**DATE:** September 14, 2022

**TO:** Mayor Tommy Allegood, City of Acworth  
**ATTN TO:** Alex Almodovar, Development Director, City of Acworth  
**RE:** Development of Regional Impact Review  
**FROM:** Mike Alexander, Director, ARC Center for Livable Communities

**Name of Proposal:** The Logan DRI 3775

**Description:** A DRI review of a proposal to construct a mixed-use development on a previously developed 16 acre site at 5200 Cherokee Street in the city of Acworth in Cobb County. The project includes 208,980 SF of medical office space, a 180 room hotel, 500 multi-family units, 15,188 SF of restaurant space, and 11,132 SF of retail space.

SITE PLAN

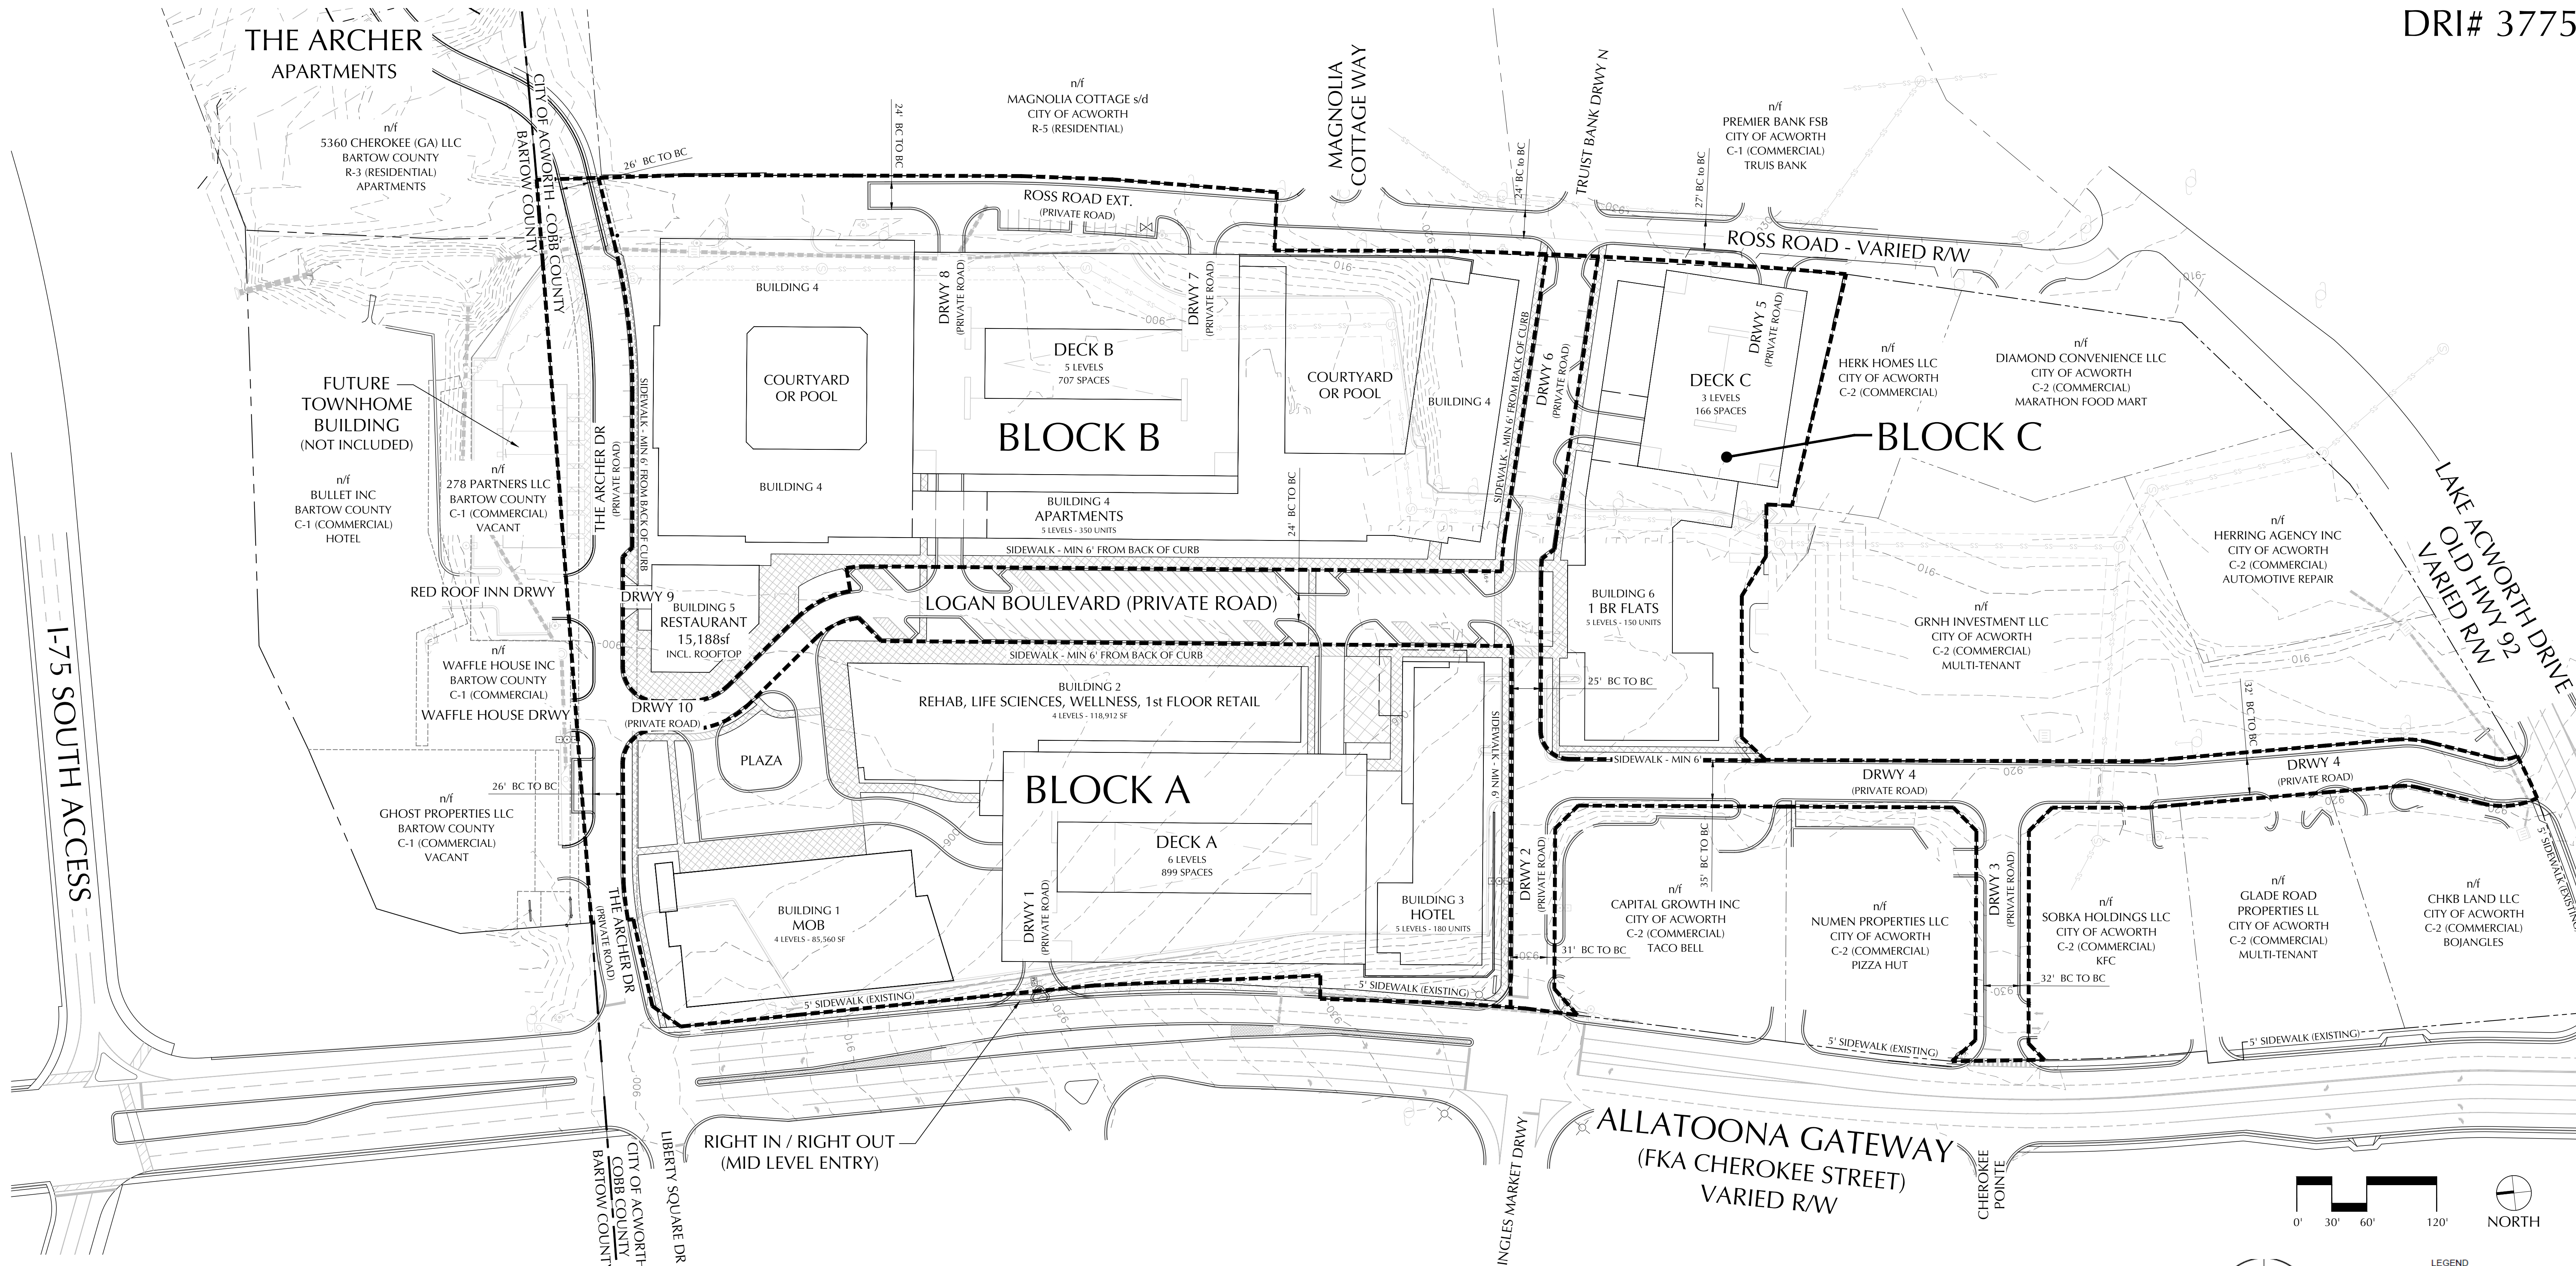
*The project's urban design falls well short of regional placemaking goals and misses the rare opportunity to create a welcoming and memorable gateway from I-75 to historic downtown Acworth in a way that extends some of the downtown character to the north. Ideally the design could be revisited to create appealing*

*architecture along the whole Cherokee Street frontage with active ground floor uses or jewel box retail/café uses fronting a very wide sidewalk with outdoor café space and a pocket park.*

The project's urban design falls well short of regional placemaking goals and misses the rare opportunity to create a welcoming and memorable gateway from I-75 to historic downtown Acworth about a mile away in a manner that extends some of the character of the historic downtown. The proposed parking deck fronting Cherokee and the mid-block driveway needed to access it is a particular concern. This driveway splits what should be a continuous walkable segment fronting Cherokee Street. Ideally the design could be revisited, as discussed at the Pre-Review meeting, to create appealing architecture along the whole Cherokee Street frontage with active ground floor or jewel box retail/café uses fronting a very wide sidewalk with outdoor café space and a pocket park. The City's Comprehensive Plan strongly embraces this concept and provides numerous images of design examples that would work well.

FUTURE TRAFFIC CONTROL AND LANE GEOMETRY

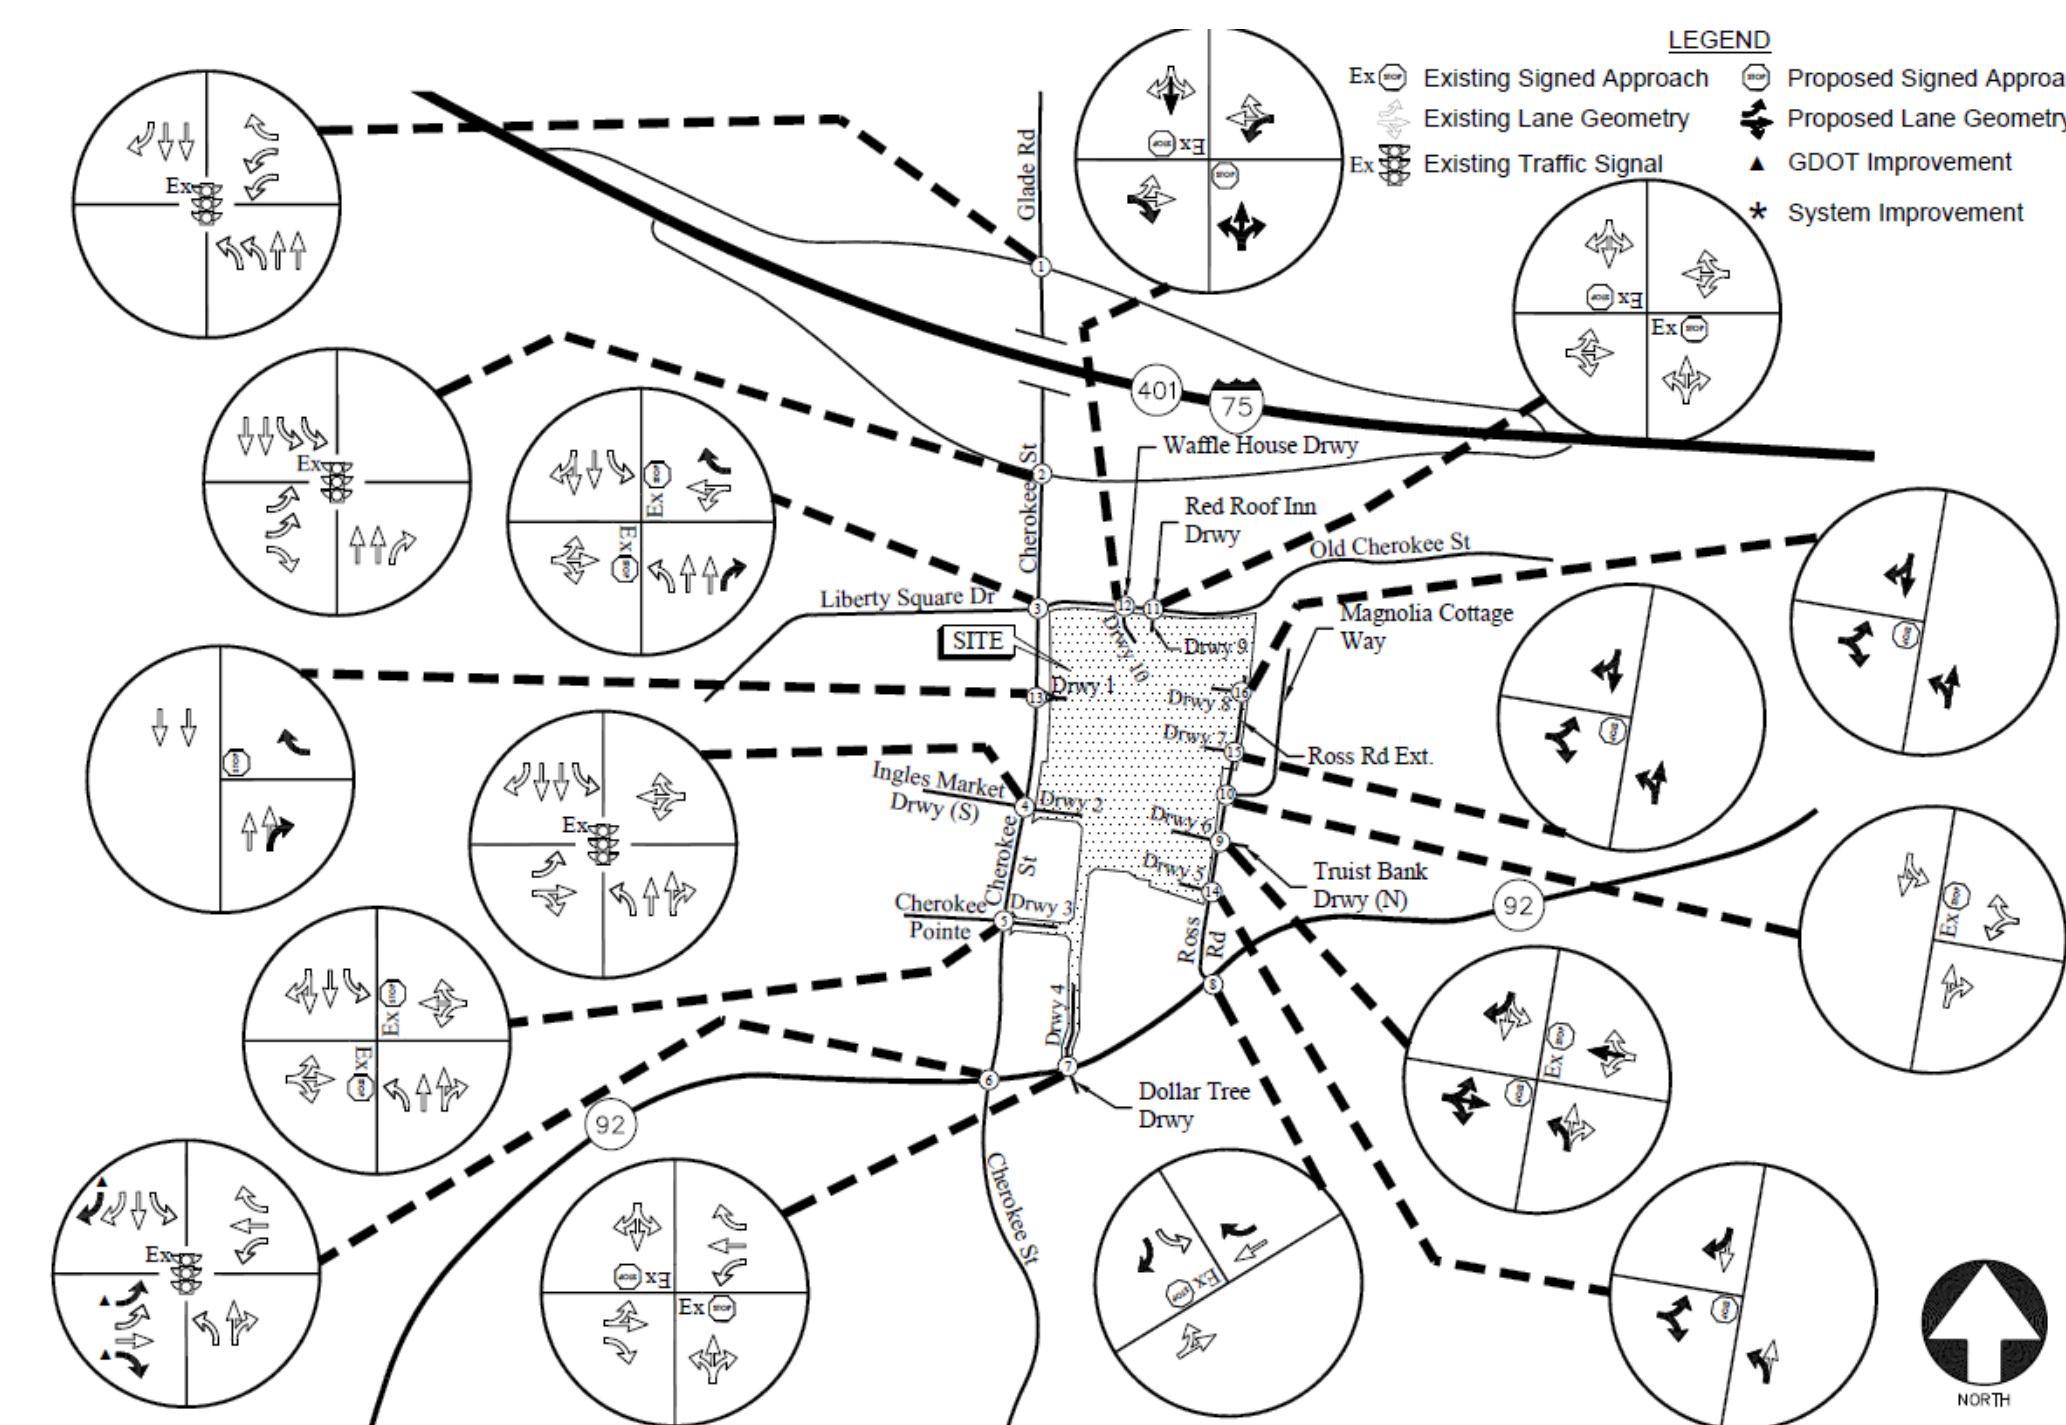
The surrounding pedestrian and bicycle infrastructure is very limited and should be substantially strengthened to provide a safe and inviting pedestrian and bicycle linkage to downtown. Guests at the 180 room hotel and residents of the 500 apartments hotel could easily bike or even walk the one mile to downtown if an appropriate route is provided. This would lessen vehicular trips and provide customers for downtown businesses. Appropriate routes and crosswalks are also needed at the Logan Place/Cherokee Street intersection so that the many residents and hotel guests can cross Cherokee Street to access the

grocery store. A signalized intersection with safe wide crosswalks is the appropriate solution at this location; the roundabout which appears to be shown is not recommended as it prioritizes continuous vehicular movement over pedestrian comfort and ease of access.
